Product hierarchy no. *				Part no.	SBU	Type / Description	Customer part no.
SBU	PG	PGU	Type				
02	005	116	0000001132	See list below		KP01 (FH) Power Entry Modul	n.a.

Product Change Notification					PCN KP01 (FH)		
owner	creation date	release date	released by	change order no	rev	page	D10-013-552
huberth	2017-01-31	2017-02-06	buerglal	2012034	A	1 of 1

Old product appearance		New product appearance	
Contact spring	Connection (caulked terminals not soldered)	Contact spring	Connection (caulked terminals soldered)

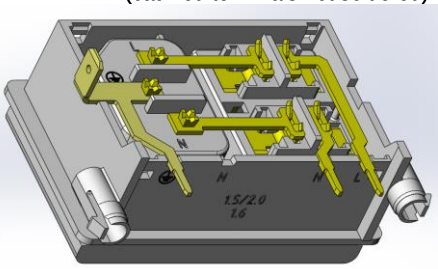
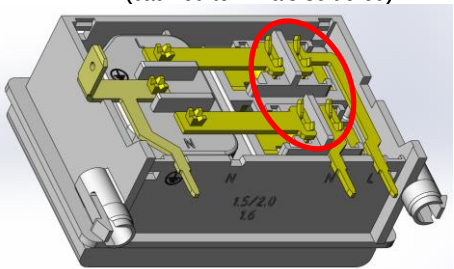
- Change of plastic material from PA6 to PBT (Socket and Fuseholder)
- Change of design of metal parts (Contact spring and Connection)

- Product improvement to fulfil the enhanced glow wire requirements according to the updated standard IEC 60127-6 and the standard IEC 60335-1 for appliances in unattended use.
- Recertification by VDE
- Recertification by UL
- Lower power dissipation due to additional soldering.
